ICC (ASC A117) CONSENSUS COMMITTEE ON ACCESSIBLE AND USABLE BUILDINGS AND FACILITIES

Legislative draft for Final Ballot

10-5-2025

Figure 503.1.4.3

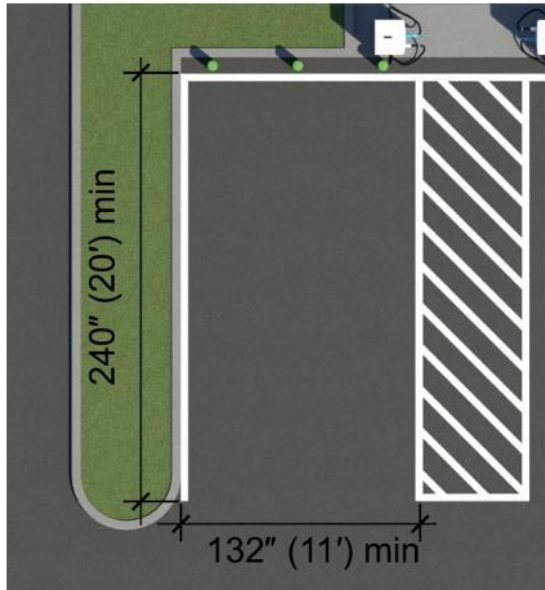
Exception: Where EV charging stations are provided at parallel parking in the public right-of-way, the access aisle for the ~~vehiele~~ EV charging space shall be permitted to comply with Section 502.9.

05-08-2021 AS/AM PC1; editorial coordination with definitions

FIGURE 607.2.1

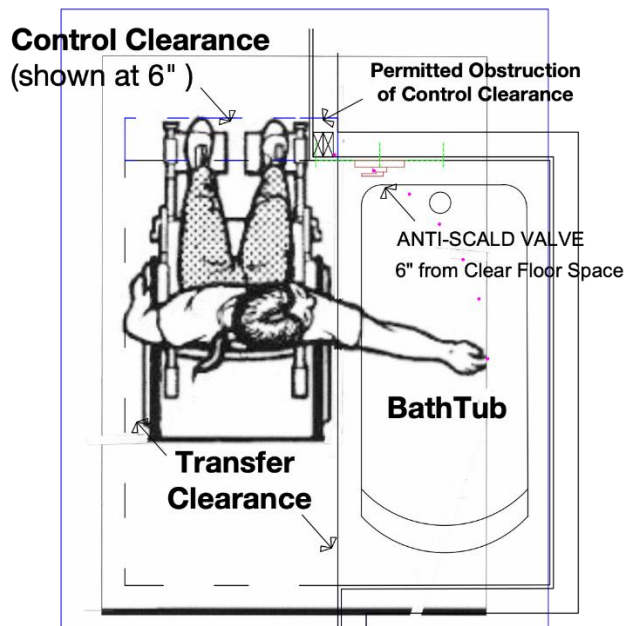
607.2.1 Clear floor space at the controls. A clear floor space shall be provided at the bathtub controls. The toe clearance portion of the clear floor space shall extend 6 inches (152 mm) minimum beyond the control end wall.

Exception: The control wall shall be permitted to overlap the clear floor space 4 inches (102 mm) maximum measured horizontally from the outside face of the bathtub.

Figure 609.7.2(A)

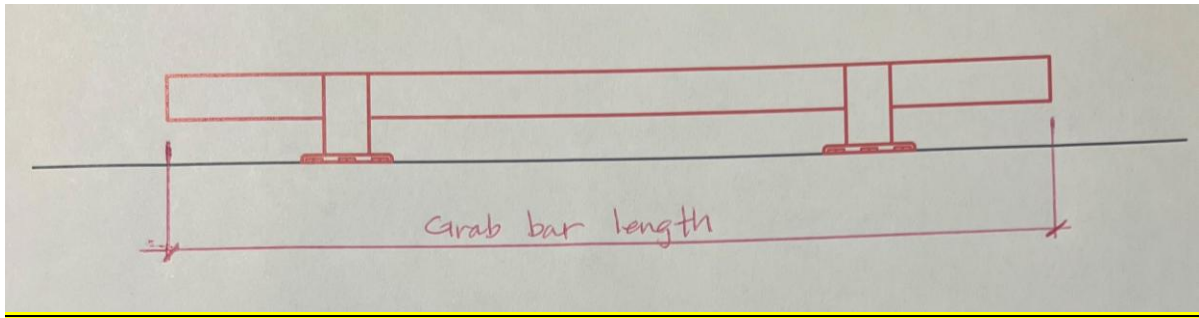
06-80-2021 AM

FIGURE 611.7(B)
ROLL-IN SHOWERS FOR ASSISTED BATHING
OPTION 2

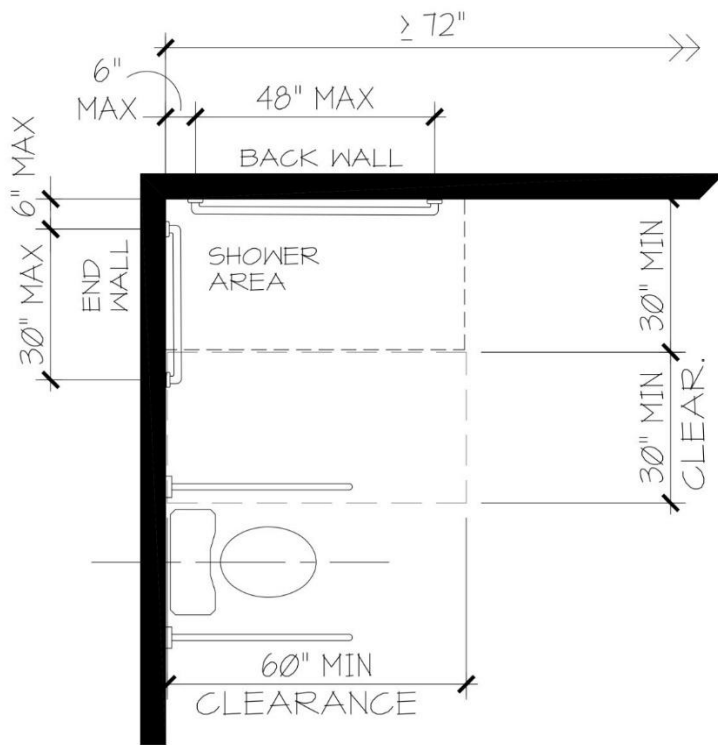
(Editorial to review minimum vs. maximum in figure)

FIGURE 611.7(C)
ROLL-IN SHOWERS FOR ASSISTED BATHING
OPTION 3

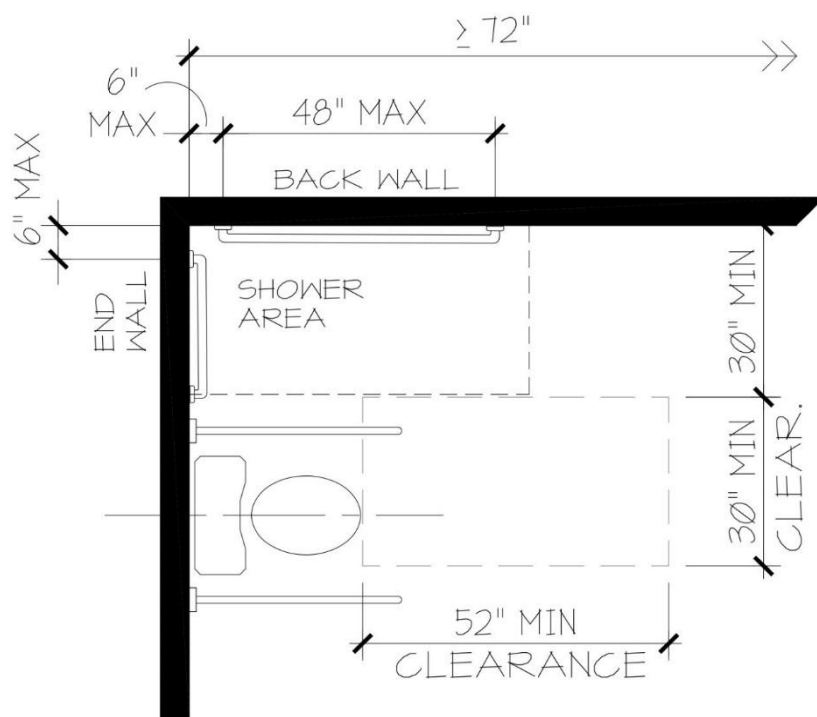
(Editorial to review minimum vs. maximum in figure)

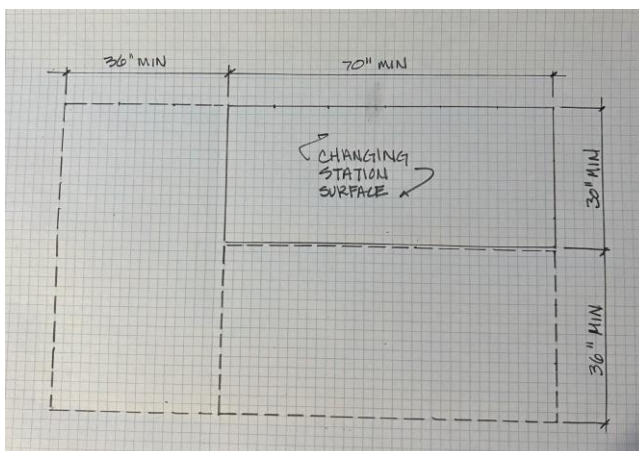
613.7.1 615.7.1 Side maneuvering clearance. A side maneuvering clearance 36-inch (914mm) minimum in depth shall be provided along the open long side of the changing surface.

Exception: In the raised position, the side rail shall be permitted to overlap the side maneuvering clearance.

Figure 703.4.4 703.1.4.3 703.1.4.2

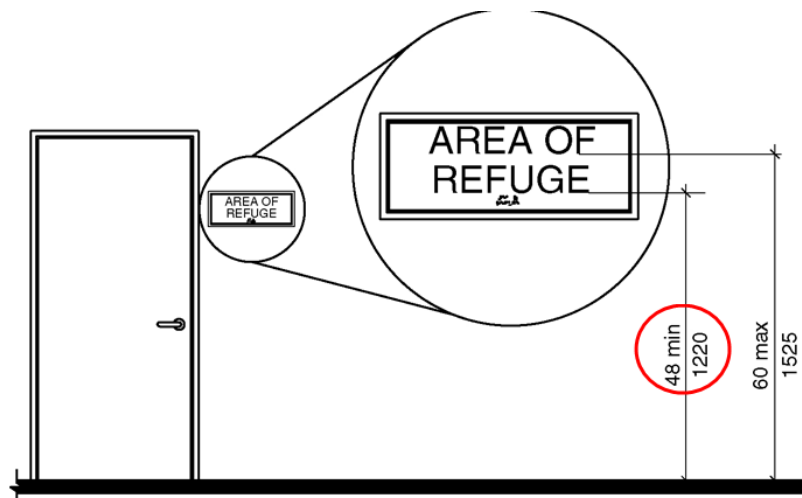
POSITION OF BRAILLE *(revise figure to match changes in text)*

Figure 908.2 DOOR AND ACCESS PANEL

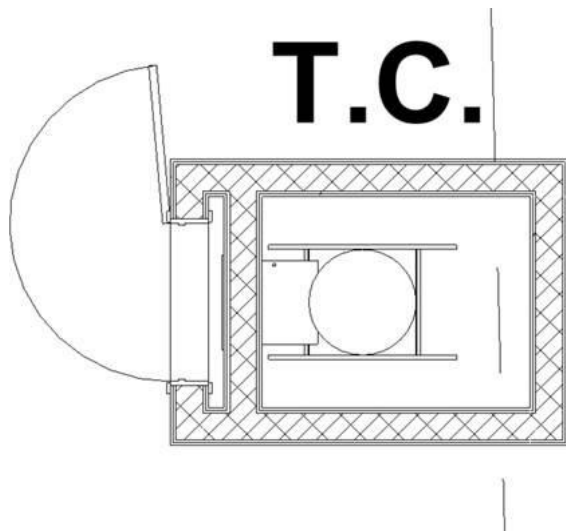
908.2 Doors. Doors to rooms that provide access to chutes shall comply with Section 404. Where a corridor door that is not for user passage conceals an access panel for the chute, the door shall comply with Section 404 on the corridor side and, shall have a magnetic hold open that allows for automatic closing upon the detection of smoke.

(Drawing should include maneuvering clearance at outside and indication of the hold open devices.)
